ADDRESS: 252 QUINCE ST

Proposal: Legalize as-built roof and dormers

**THE MINUTES OF THE 747TH STATED MEETING OF THE
PHILADELPHIA HISTORICAL COMMISSION**

252 Quince St – New cornice details

A-201 EXTERIOR ELEVATIONS
 DANIELLE HARVEY
 252 QUINCE ST.
 PHILADELPHIA PA 19107
 11/18/2024

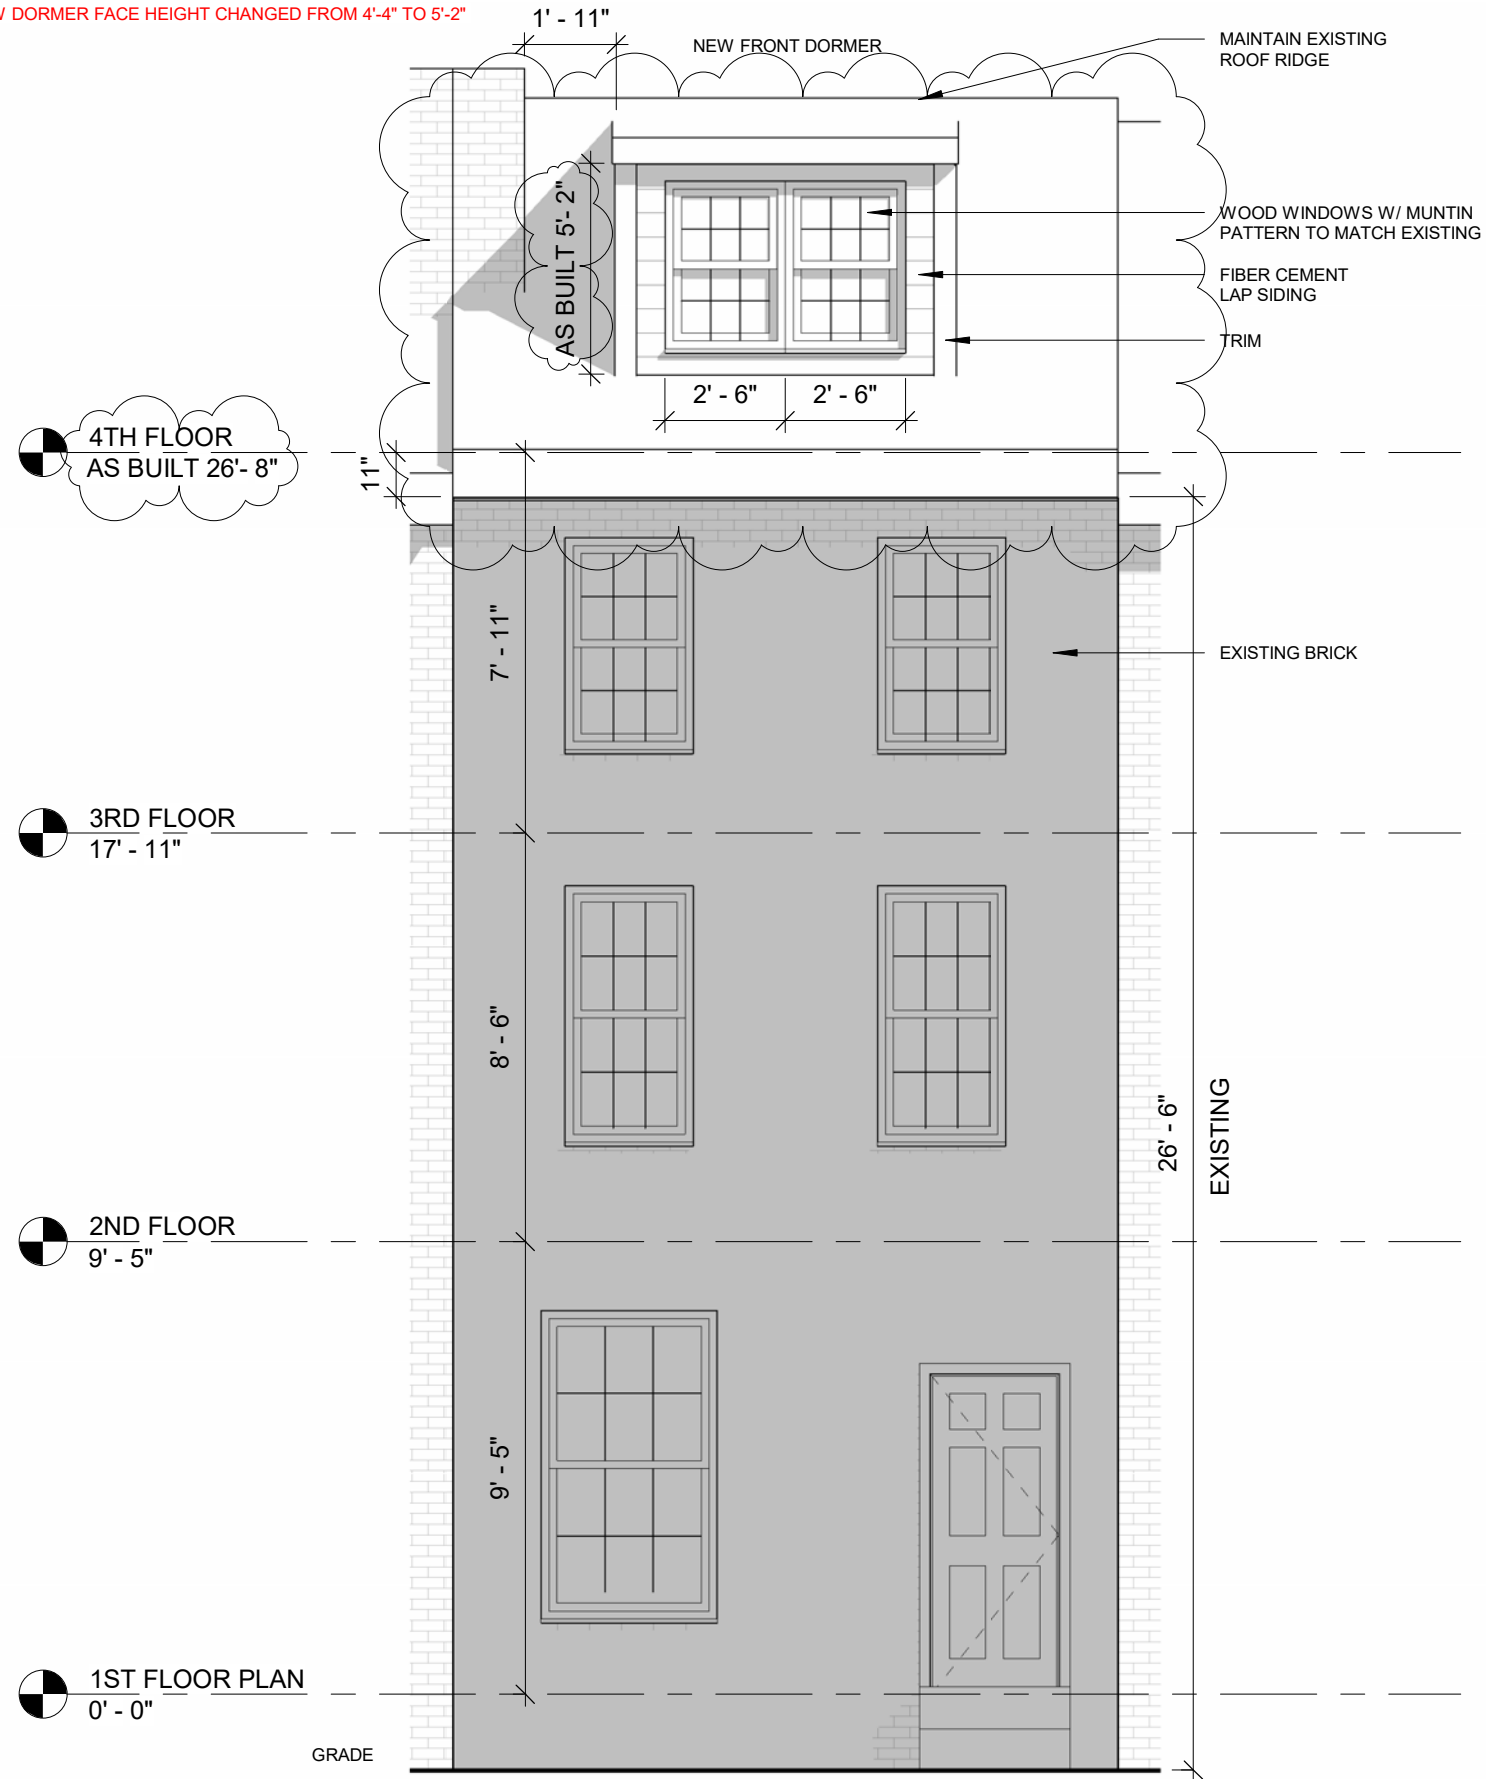
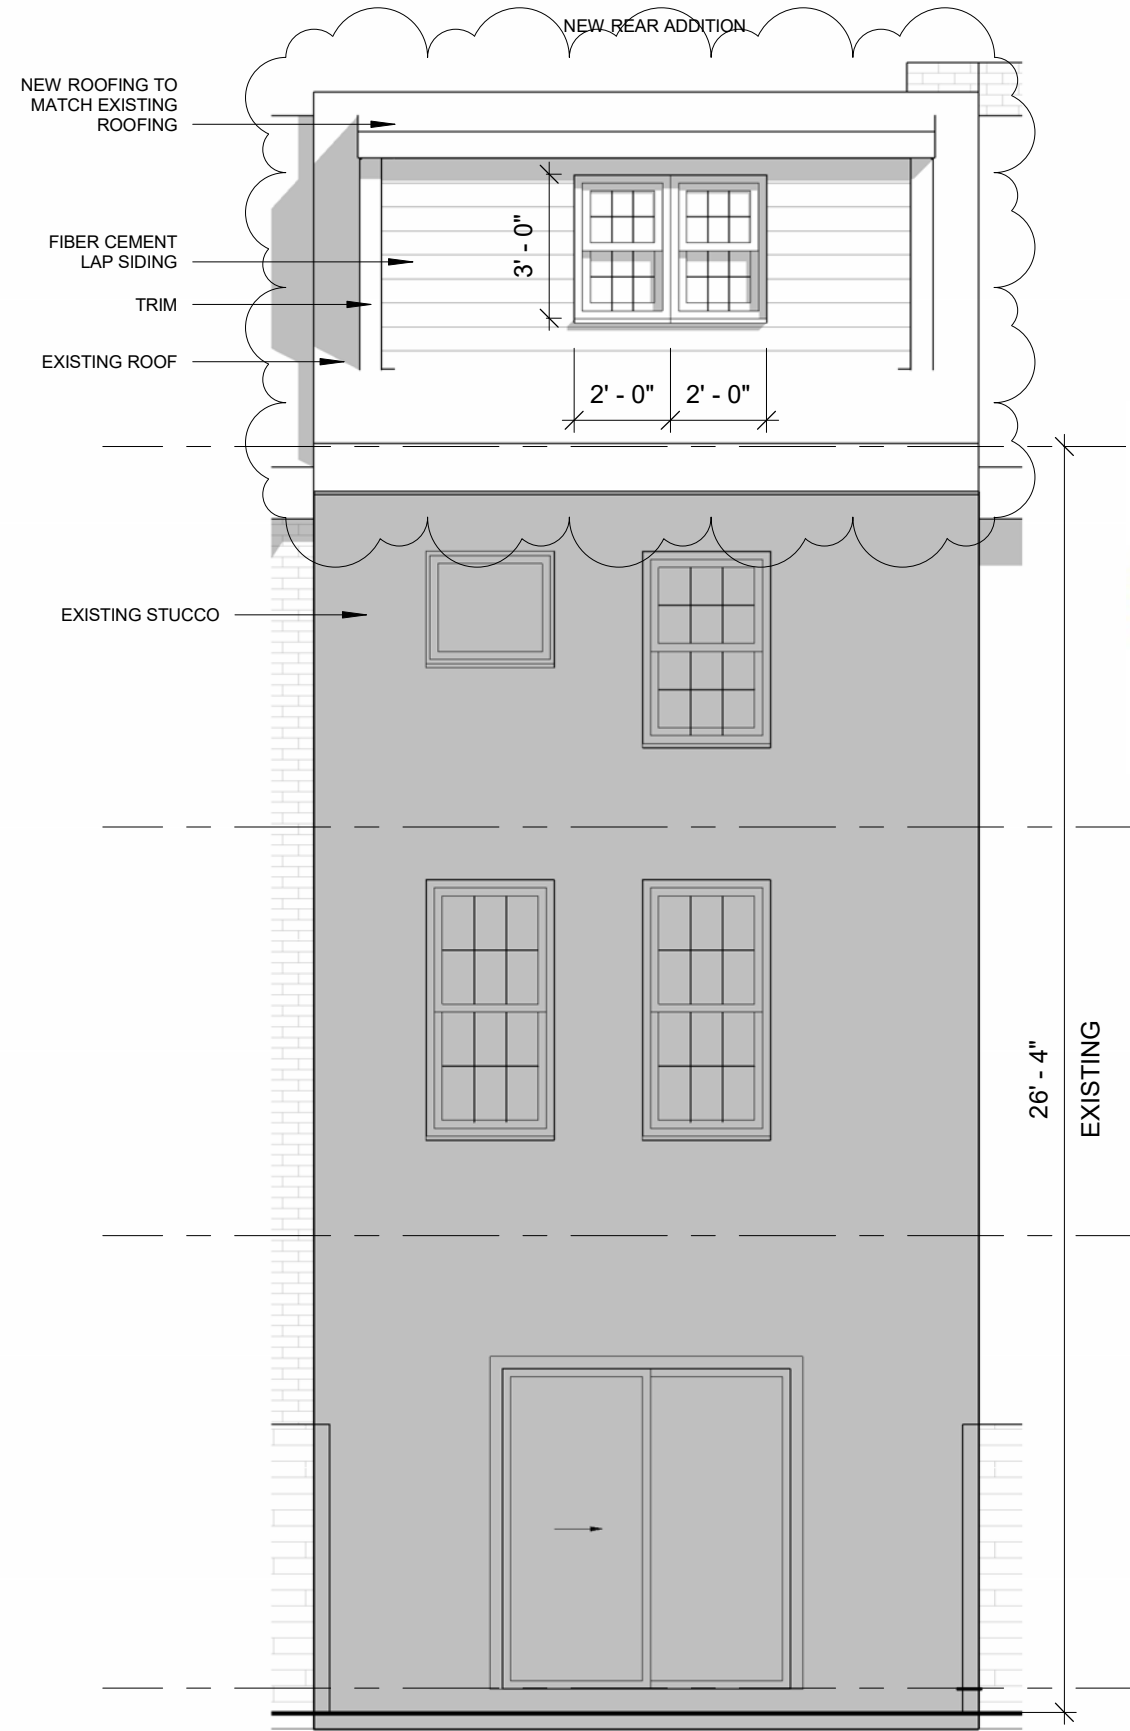
- Front and rear dormers were constructed 10 inches taller than approved plans and the dormer cornices are oversized. As currently constructed, the dormers are highly visible from the public right-of-way and fail to satisfy the roof guideline.

- Front and rear dormers were constructed 10 inches taller than approved plans and the dormer cornices are oversized. As currently constructed, the dormers are highly visible from the public right-of-way and fail to satisfy the roof guideline.

AS BUILT CHANGES INCLUDE:
 -EXISTING ROOF AND CORNICES REPLACED WITH NEW
 -NEW ROOF IS 10" HIGHER THAN EXISTING
 -NEW DORMER FACE HEIGHT CHANGED FROM 4'-4" TO 5'-2"

STAFF RECOMMENDATION: Approval, provided the cornices align with those of the neighboring buildings, as suggested by the Historical Commission, pursuant to Standards 9 and 10, and the Roofs Guideline.

- Revised drawings and documentation must be submitted that address the Historical Commission's key concerns. This includes reconstruction of the cornice, reconstruction of roof profiles at the front and rear to match the historic row, and a reconfiguration of the dormers to a more historically compatible appearance. The revised application should be remanded to the Architectural Committee for review and discussion.

6 DETAIL @ NEW CORNICE
1" = 1'-0"

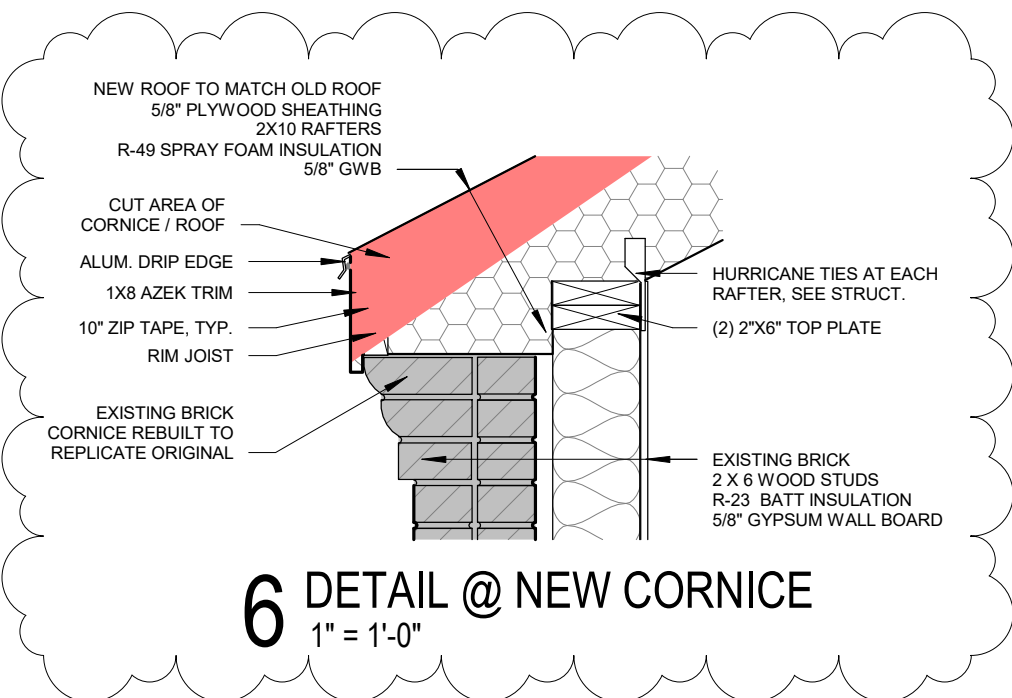
- Custom made brick has been ordered to rebuild the front cornice in kind.
- The current amended drawings do not sufficiently document the solutions proposed by the applicant. The application should be revised to bring project back into compliance.
